# UNITED STATES PATENT AND TRADEMARK OFFICE

APPLICATION NO.	FILING DATE	FIRST NAMED INVENTOR	ATTORNEY DOCKET NO.	CONFIRMATION NO.
10/595,342	04/11/2006	Terje H. Houen	1935-00233	7881
26753 7590 06/08/2010 ANDRUS, SCEALES, STARKE & SAWALL, LLP 100 EAST WISCONSIN AVENUE, SUITE 1100 MILWAUKEE, WI 53202				
EXAMINER CAMPOS, JR, JUAN J				
ART UNIT 3654		PAPER NUMBER		
MAIL DATE 06/08/2010		DELIVERY MODE PAPER

### Office Action Summary

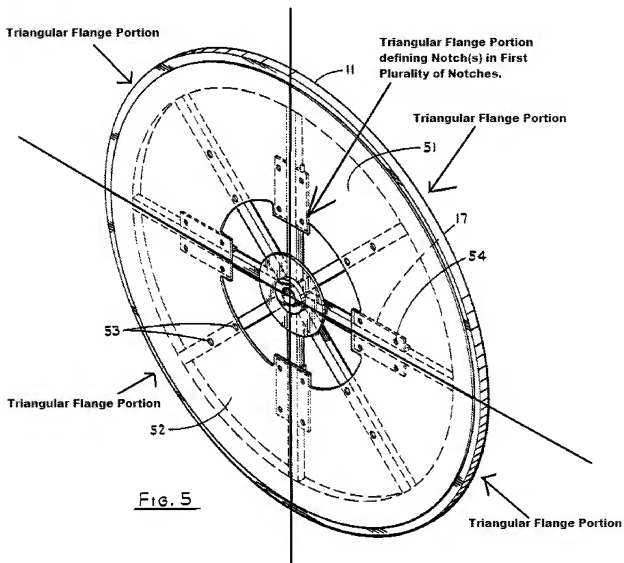
**47. Regarding claim 35,** Harvey further shows wherein each flange sector 51 is capable of comprising a series of triangular flange portions (see column 5 lines 7-12.

figure 5 and figure below), the triangular flange portions defining notches in the first plurality of notches (see figure 5 and figure below).

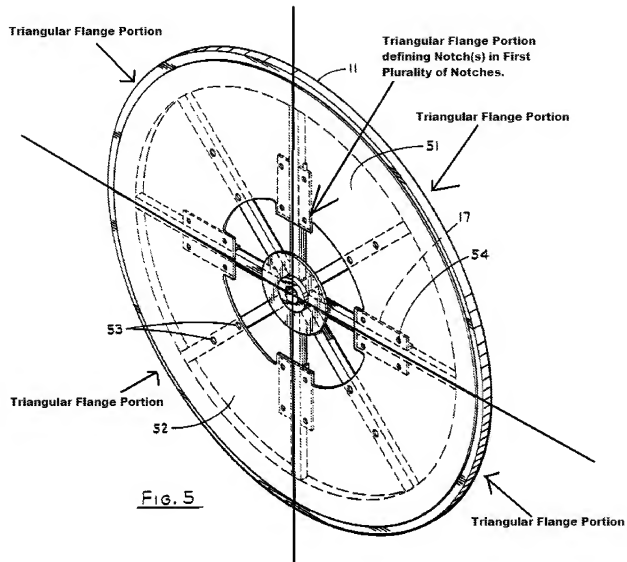
**51. Regarding claim 50,** Harvey further shows wherein each flange sector 51 is capable of comprising a series of triangular flange portions (see column 5 lines 7-12. figure 5 and figure below), the triangular flange portions defining notches in the first plurality of notches (see figure 5 and figure below).
